SUBJECT: **REVISED WASTE DISCHARGE REQUIREMENTS FOR MOLYCORP
MINERALS LLC, MOUNTAIN PASS MINE AND MILL, SAN
BERNARDINO COUNTY**

**BOARD ORDER NO. R6V-2010-(PROPOSED)
WDID NO. 6B362098001**

**MOLYCORP MINERALS LLC
MOUNTAIN PASS MINE AND MILL OPERATIONS**

PROPOSED CLARIFICATION POND LINER DETAILS

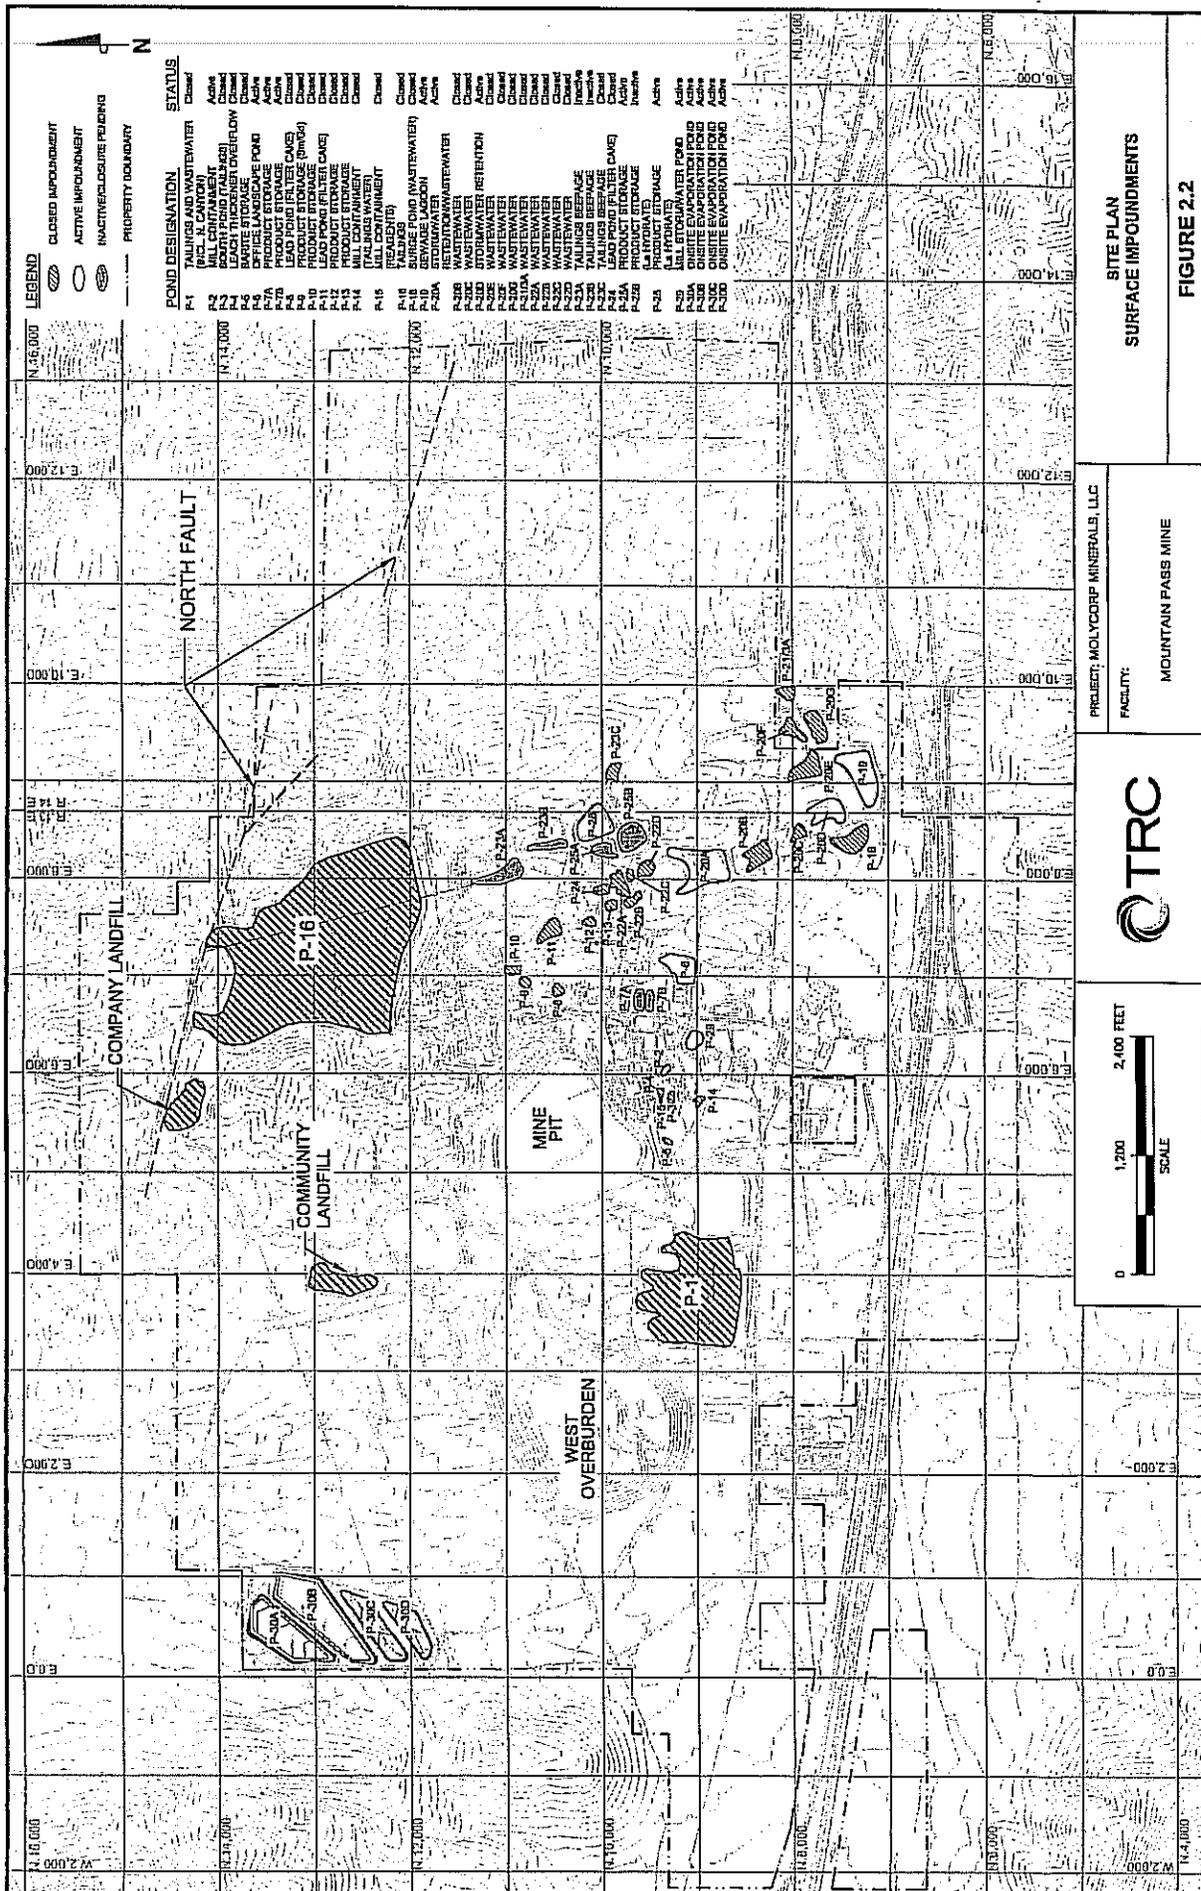
- ii. The proposed Clarification Pond liner system consists of a reinforced concrete top liner, underlain by a 1-foot-thick gravel drainage layer underlain by a 60-mil HDPE liner. A 4-inch-diameter perforated HDPE pipe will be installed in the drainage layer and extended to the surface to provide monitoring and removal of any leakage, Attachment "F," which is attached to and made a part of this Order. The Clarification Pond will provide storage, settling and clarification of paste plant filtrate, thickener overflow, and sumpage water from the paste plant as well as water pumped from the Reclaim Pond. The clarified water will be returned to the paste plant and mill for reuse or used as needed for dust control on the NWTDF. The settled solids will be periodically removed and re-incorporated into the paste tailings process. The proposed concrete top liner does not meet prescriptive standards in CCR, title 27, section 22490. The Discharger has not demonstrated that concrete liner will meet or exceed performance goals pursuant to CCR, title 27, section 22490, subsection (f)(6). The Discharger is required to propose a liner design that will satisfy prescriptive standards for the top liner component of the Clarification Pond.

Comment [SH3]: OK, this appears to indicate that the final design will meet prescriptive liner requirements
